Bulletin No: 2019 MJ01 - Rev. 01

SERVICE BULLETIN

Ride Name: Mini Jet

Align older rides with most current non-destructive testing (NDT) and replacement schedule.

IMAGE 7 - BASE FRAME

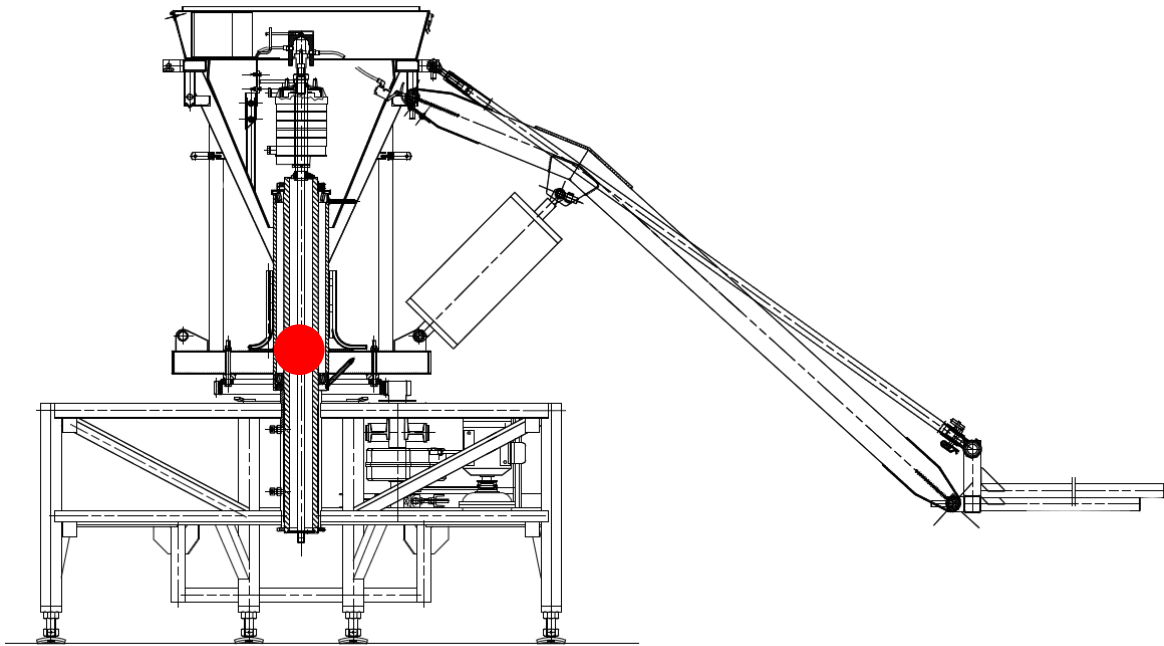
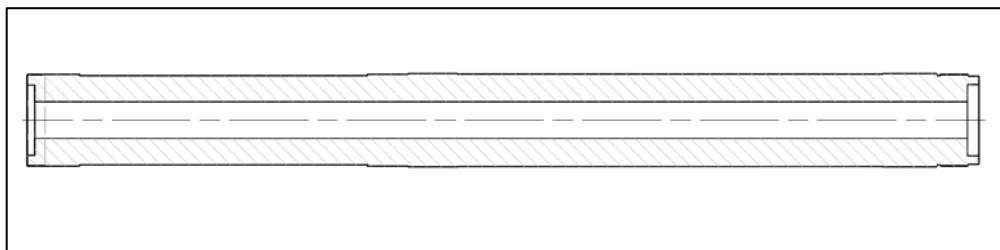
| Item | Part Number | Component and Location | Image # | Test method code | Test every (Time Code) | Remarks |
|------|-------------|------------------------|---------|------------------|------------------------|---|
| 9 | | Base Frame | 7 | VT | M6 | Check welds. Check for cracks, corrosion. |

(*) VT(M6)
MT(Y4)
